16 March 2021  
Selwyn District Council  
CHRISTCHURCH

**Request for Further Information: Plan Change 72**

**REQUEST DOCUMENT**

Figure 1: PC72 site (outlined in red) and adjoining existing L3 zone to the west

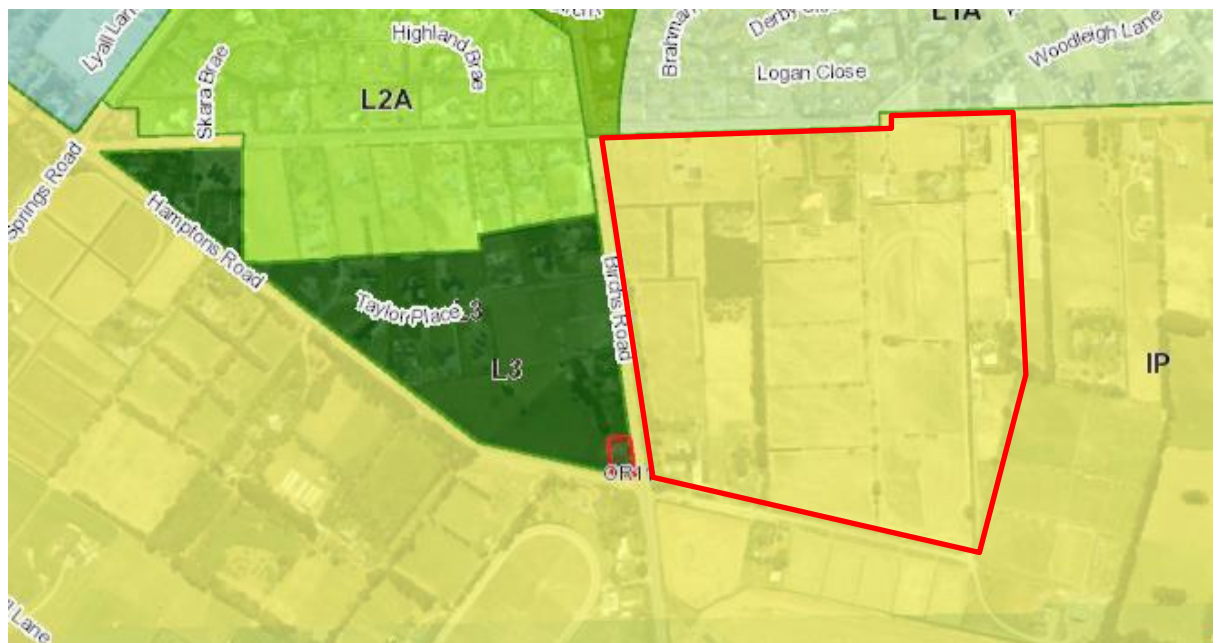
**6. Please explain why Living 3 is an appropriate zoning for part of Birch's Road (including given the existing active public transport/bus route) and discuss how future intensification can successfully occur within this area without compromising good urban design principles.**

The Living 3 zone has been chosen to allow for the necessary lot sizes required to accommodate the existing dwellings as well as a generous setback to prevent shading of dwellings and associated outdoor areas by the large trees and dense vegetation that is to be retained along Birchs Road. This density also reflects the nature of the development on the adjacent land to the west across Birchs Road with approximately 50% of the block developed as larger residential sites creating a low density environment.

The southern part remains rural and is used for infrastructure and services (electricity). Retention of the established vegetation, provides a visual screen towards the road and the utility area but more importantly it will continue to support the formation a natural gateway into Prebbleton framed by large trees.

With regard to future intensification, the Living 3 area could be further intensified by either subdividing each of the 5000m<sup>2</sup> lots into 4 x 1250m<sup>2</sup> around a shared access or by identifying building platforms from the outset in the Living 3 zone to ensure dwellings are located in a manner that will allow for a Living Z type density to be achieved long term. However, this would require the removal of the vegetation strip with mature trees along this part of Birchs Road and compromise the natural gateway into the township.

The bus route on Birchs Road is a public transport route connecting Lincoln with Christchurch and is one factor supporting residential intensification. For that purpose a pedestrian link has been included to provide connectivity through the Living 3 zone to the Living Z area.

Figure 2: Possible rising main route

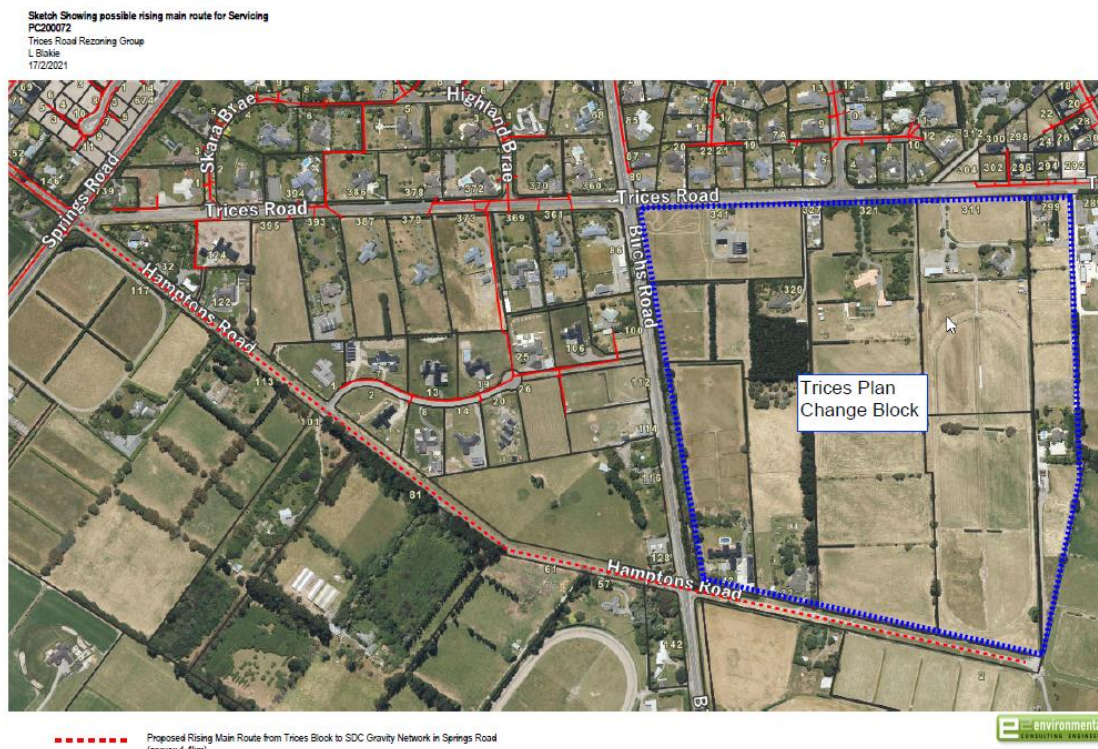
- 27. Council has constructed a new terminal wastewater pump station located at 612 Springs Road. Please comment on the feasibility for this proposed plan change area to be serviced by a reticulated wastewater system pumping directly to this wastewater pump station. Please contact Murray England Asset Manager Water Services ([murray.england@selwyn.govt.nz](mailto:murray.england@selwyn.govt.nz)) for further information.**

The applicant's servicing expert (E2 Environmental) has advised that, based on the residential zoning yield of approximately 295 lots (including 5 large lot residential lots), they estimate from the SDC Engineering Code of Practice (6.4.4) that the maximum flow generated will be:

Average Sewer Flow ASF  
= 295 lots x 220 L/p/day x 2.7 persons/lot  
= 175,230 L/day or 2.03 L/s

Maximum Sewer Flow MF  
= 2.03 L/s x 2.5 x 2 (peaking factors)  
= 10.1 L/s.

This maximum flow assumes full development of the area with no further infilling possible. The likely position for gravity wastewater pump station is in the south east of the plan change block where all of the site can drain by gravity to a low point. It is likely that a pump station will be on the proposed stormwater utility reserve nearest Hamptons Road.

A rising main would pump wastewater from this location westward along Hamptons Road approximately 1.4km to the intersection of Hamptons and Springs Road and discharge into the SDC gravity sewer network at or near this intersection. This network drains to a new wastewater pump station (WWPS) recently installed at 612 Springs Road (**Figure 2**).

E2 Environmental has corresponded with Murray England (Asset Manager Water Services) and Amit Chauhan on wastewater servicing. Amit Chauhan verbally confirmed that there is capacity in the Council's new wastewater pump station for this flow.

Any upgrades to the network between the Springs Road connection point and the pump station will be discussed and agreed during the subdivision consent phase.
